## Service Bulletin SB 2047:

<b>Title</b>	RW-1019 Washer Issue for 2005 and Newer Ford F-450/550's
<b>Document No.</b>	SB 2047
<b>Issue Date</b>	3/15/06 (WAK) Revised 4/24/06
<b>Units Affected</b>	Model year 2005 and newer Ford F-450s and F-550s
<b>Purpose</b>	This service bulletin addresses an installation error regarding RW-1019 front railgear on model year 2005 and newer Ford F-450's and F-550's.

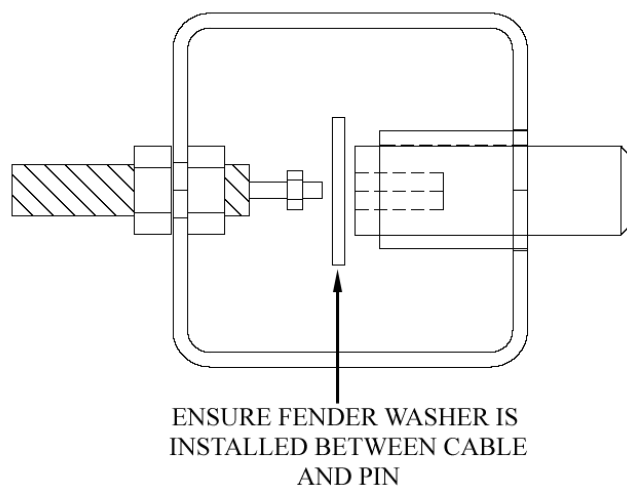
The illustration below shows the cable operated pin off assembly for RW-1019 railgear which is standard on models for 2005 and newer Ford F-450/550s. There should be a fender washer installed between the remote cable operator and the actual pin itself. The washer prevents the pin from being over inserted into the guide tube. Over insertion can allow the pin to become cockeyed in the guide tube and snap the pin-off cable where it threads into the pin.

If there is no washer, a new one must be installed.

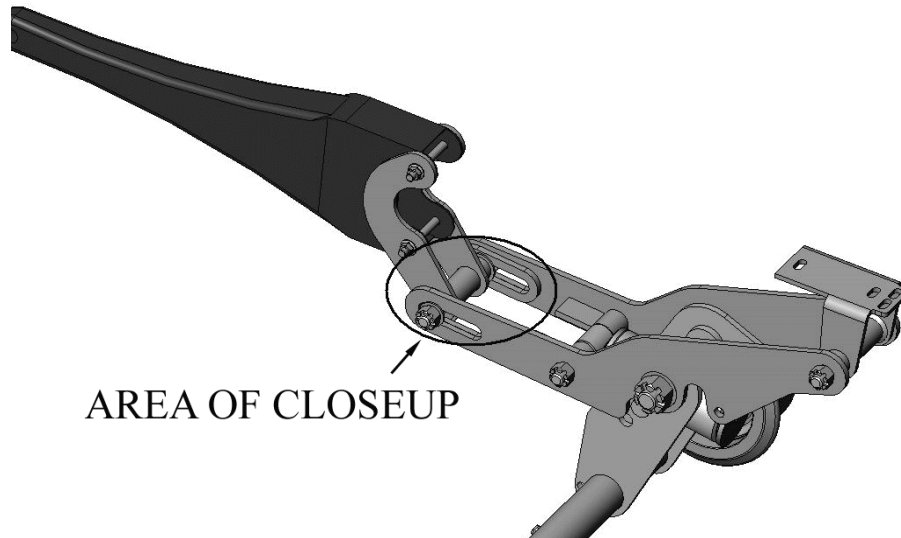
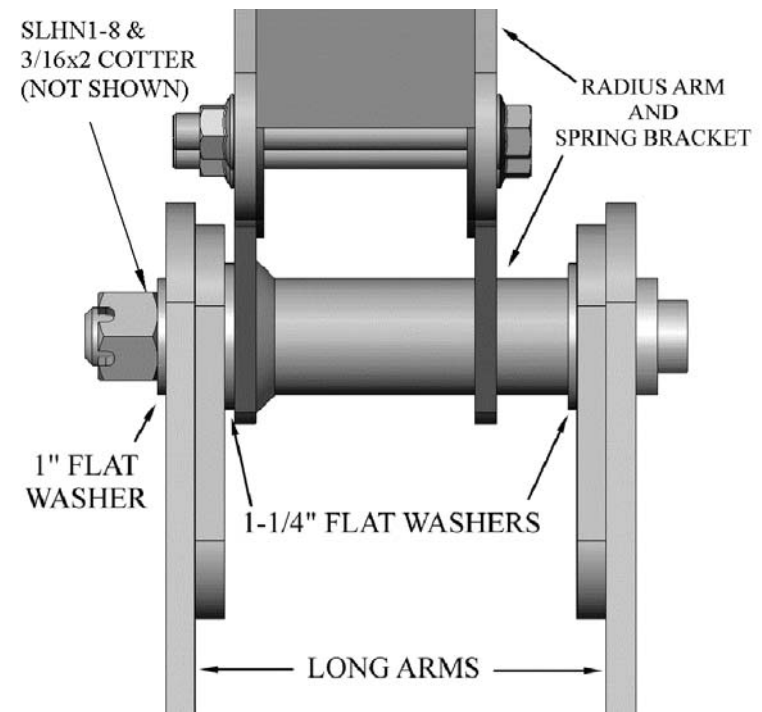
The picture below shows the driver's side of a front set of RW-1019 railgear for a 2005 model year Ford F-450/550. For each side of the truck there are supposed to be 3 washers for the rear pin. There is supposed to be a 1-1/4" washer between each long arm and the spring bracket bolted to the radius arm. Additionally there should be a 1" washer between the inner long arm and the castellated nut.

Please see the close-up diagram below for proper washer location.

Identifying excessively worn Long Arms

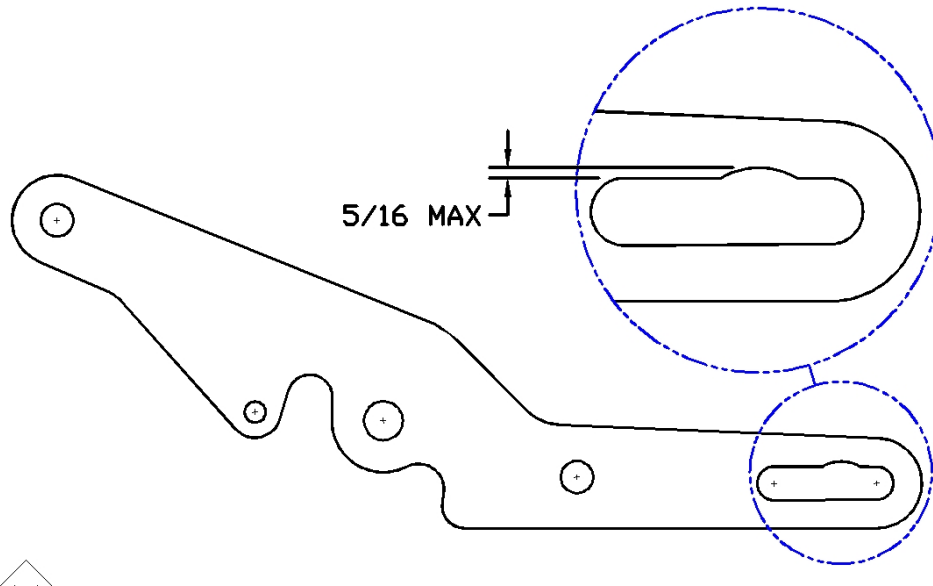
- Inspect slotted area of each long arm for excessive wear as shown above. Replace if necessary.
- Inspect 1" Slotted nut for excessive wear. Replace if necessary.
- Any unusual or excessive wear should be directed to DMF engineering for evaluation.
- All warranty claims must reference the railgear's serial number.
